# JABIRU AIRCRAFT PTY LTD

## SERVICE BULLETIN: JSB 012-3

**Date:** 30<sup>th</sup> June 2016

**Subject:** Jabiru Engine Flywheel Attachment

Figure 2 - Plain washers compared to Nordloc washers

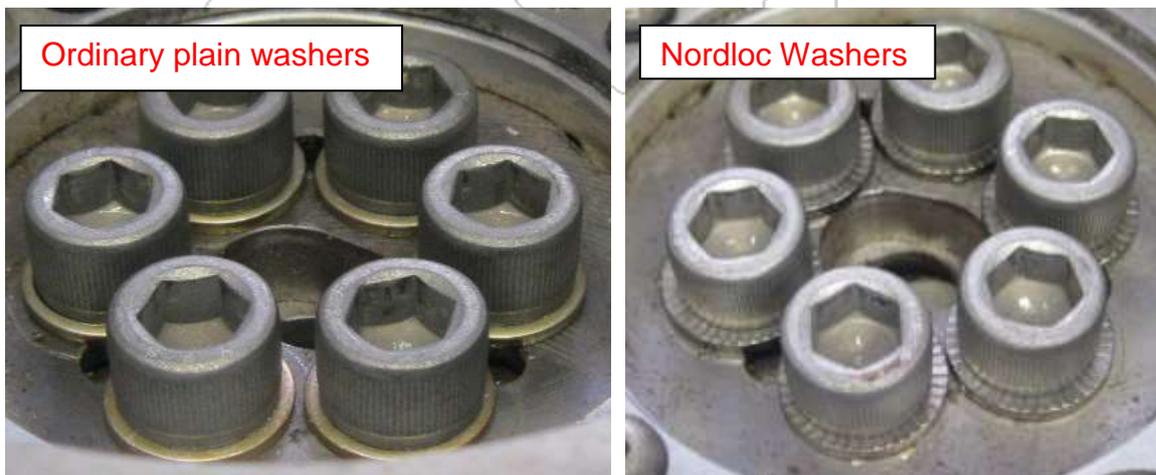
This revision of this service bulletin also acts to inform maintainers and operators of a design change to the flywheel connection which should be implemented on existing engines whenever flywheel bolts are replaced (i.e. at the intervals specified in JEM0001 or at overhaul).

Flywheel screws must now be installed using Nordloc washers (replacing the previous installation which used either plain or Belleville washers). Jabiru engines of any and all flywheel configurations (as defined in Table 1) should now use Nordloc washers. These washers are easily identified via visual inspection as shown below in Figure 2.

Refer to the Jabiru Engine overhaul manual JEM0001 (always check for the latest revision) for the installation procedure of flywheel capscrews using Nordloc washers. The major difference in installation is that bolts installed with Nordloc washers **must not be installed with Loctite**. The torque setting is also different for capscrews installed with these washers
